Intel® 82577 GbE PHY Specification Update

February 2010
Revision 1.6

322614-002

Figure 1. Typical Top Marking Example With Identifying Marks (82577LC Shown)

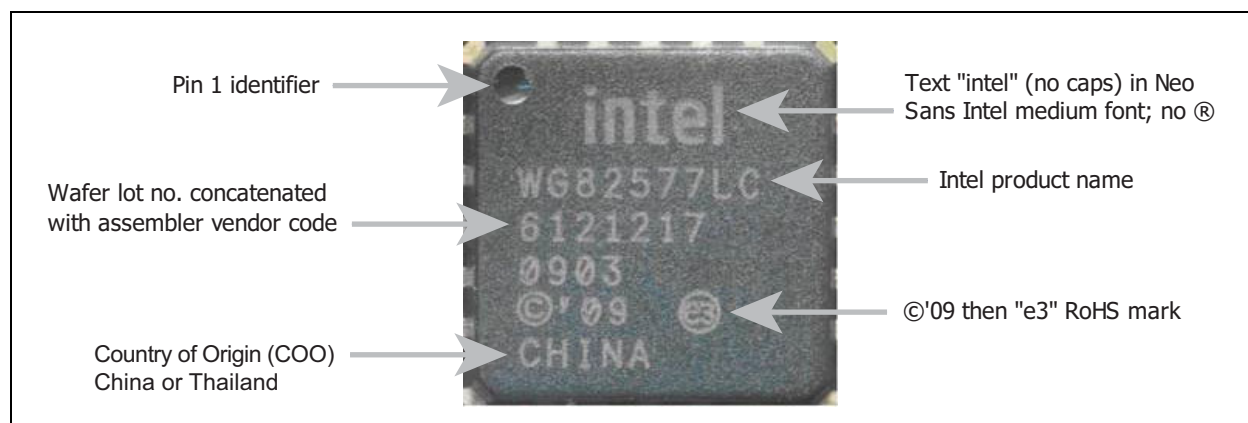
Date	Revision	Description
February 2010	1.6	Added Thailand as a Country Of Origin (COO) to Figure 1.
January 2010	1.5	Added Specification Clarification #1. Removed Erratum #2.
November 2009	1.4	Removed Specification Change #1. Added Erratum #2.
September 2009	1.3	Initial Public Release.
